CITY OF ALBUQUERQUE

**RE: MDS - Montage Subdivision Unit 7 on Bobby Foster
Grading and Drainage Submittal for Preliminary Plat and Grading Permit
Grading Plan Engineer's Stamp Date: 8/16/2023
Hydrology File: R16D100A**

Based upon the information provided in your submittal received 12/11/2023, the Grading & Drainage Plan is not approved for Building Permit. The following comments need to be addressed for approval of the above referenced project:

GRADING COMPOSITE

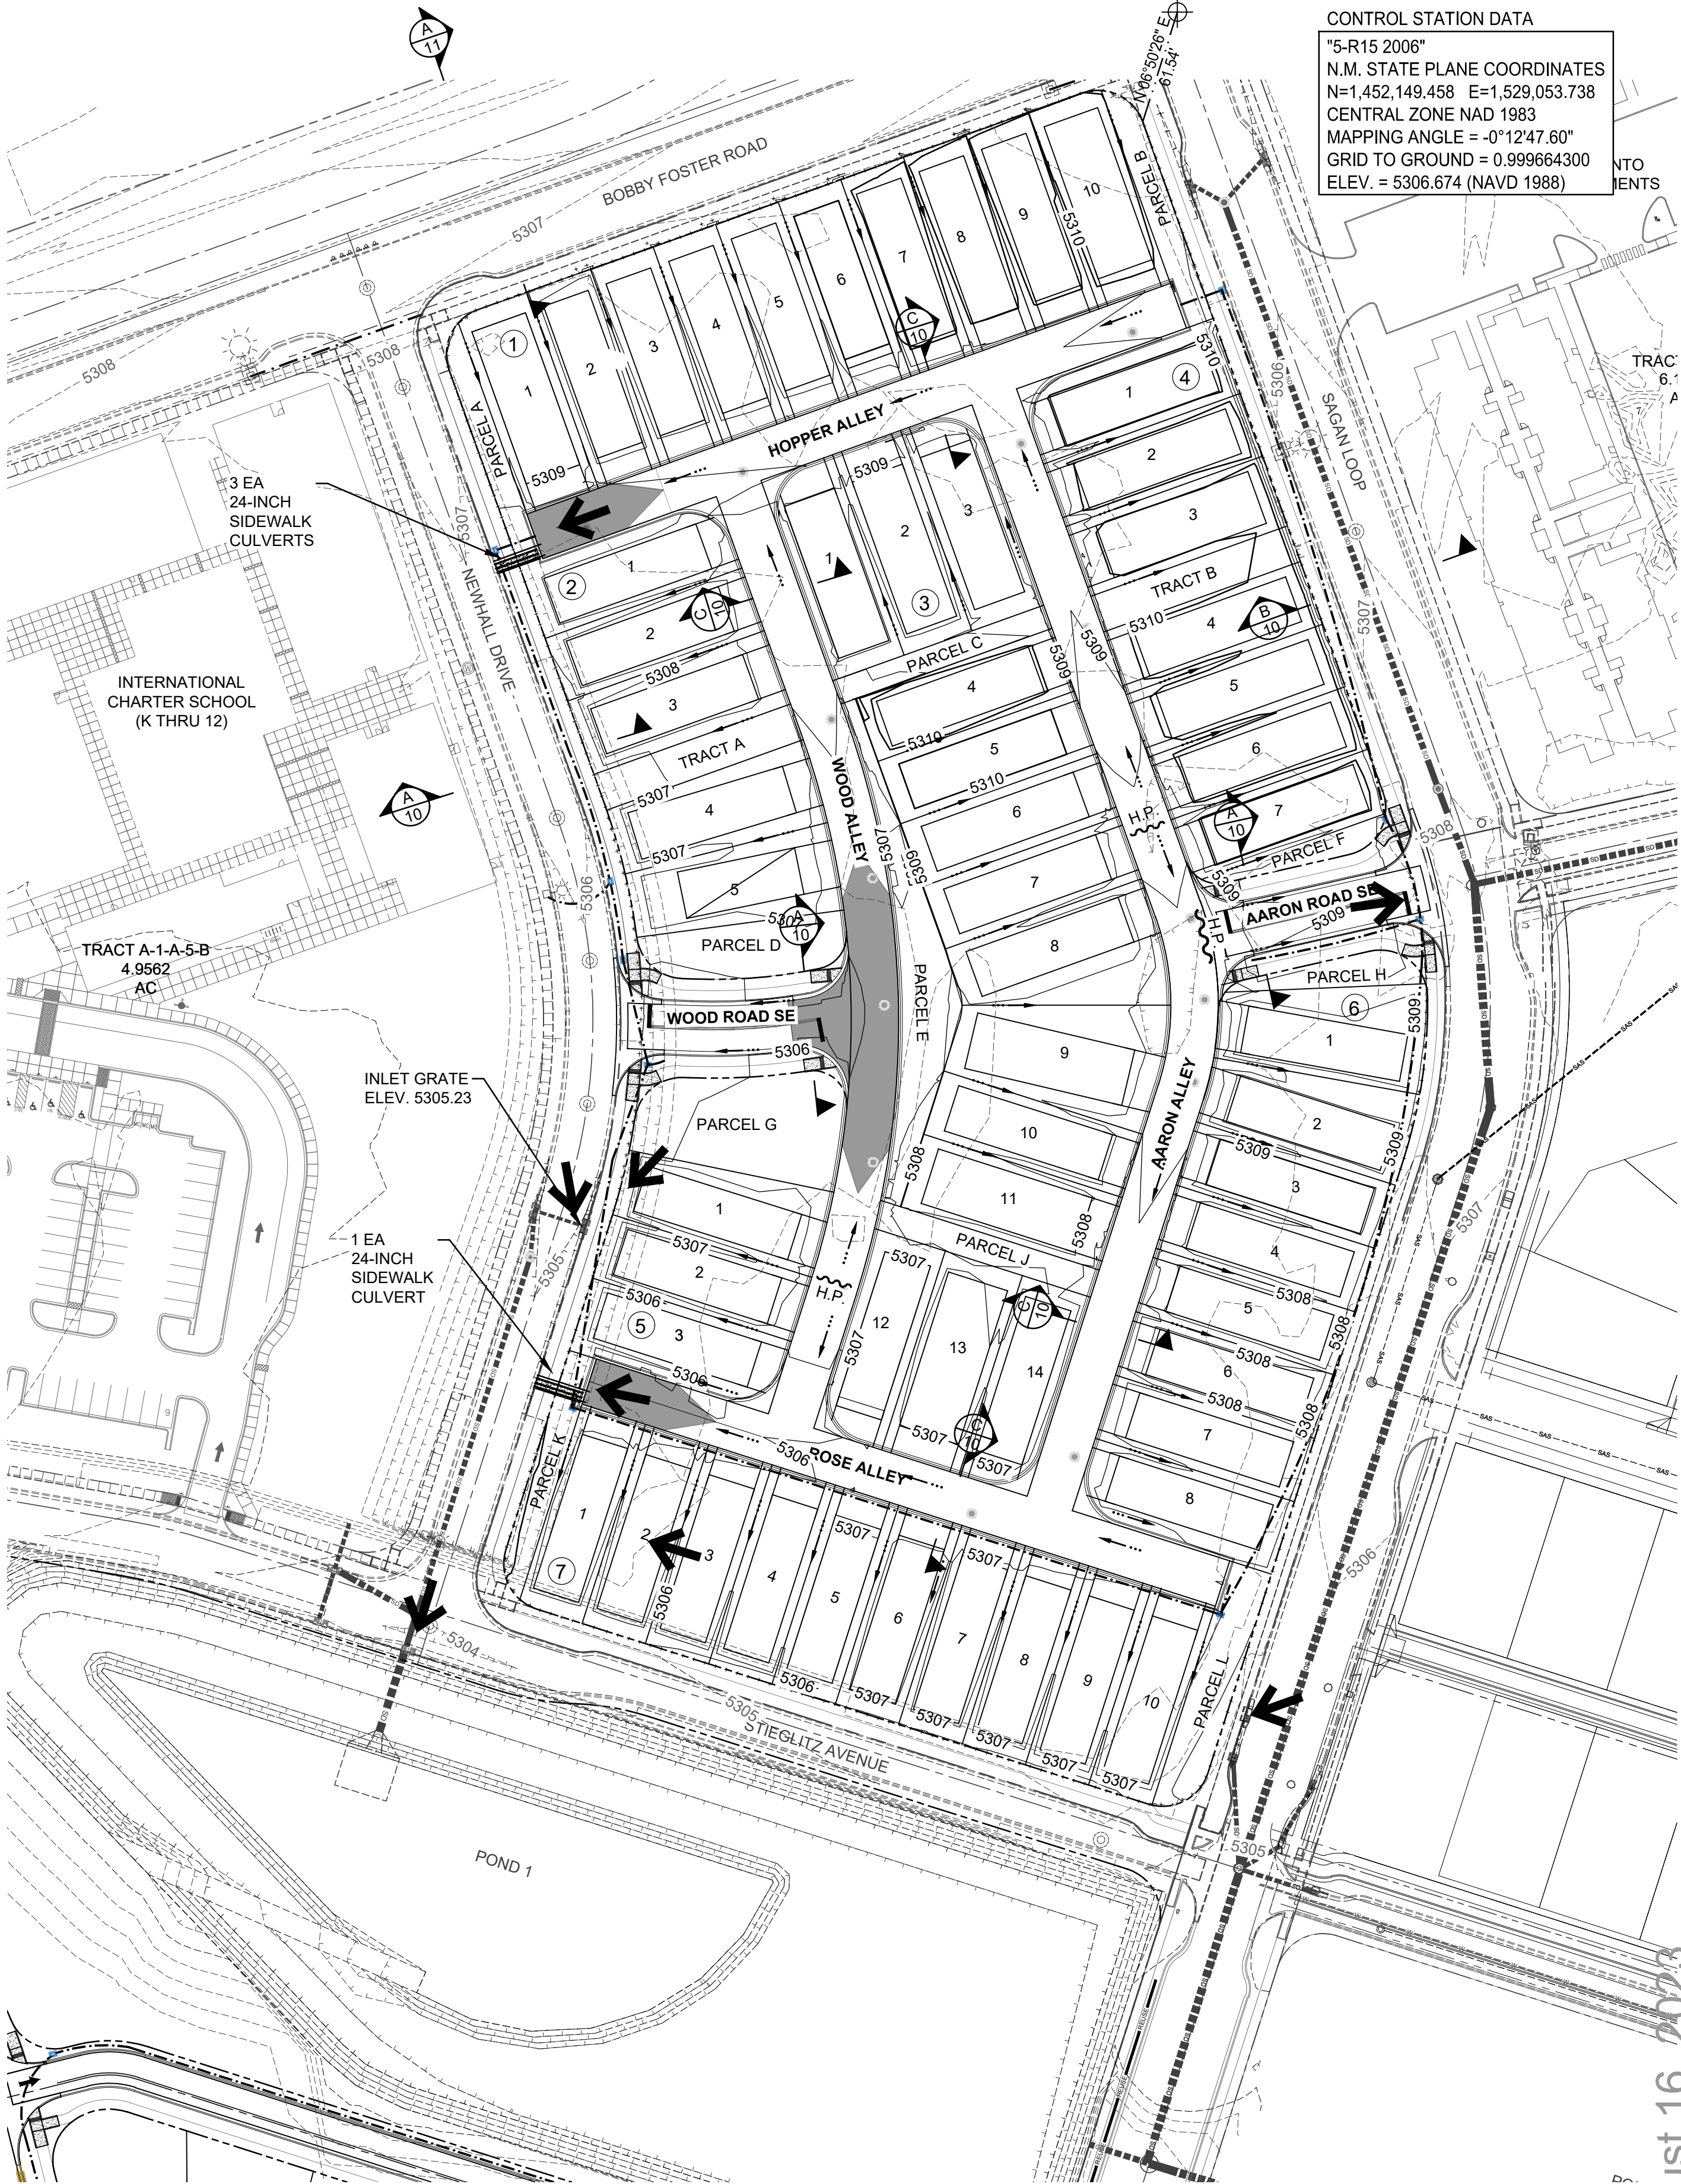
4. Change the “,” to “.” in the area of disturbance to 7.5 on sheet 1.
AREA OF DISTURBANCE IS APPROXIMATELY 7,5
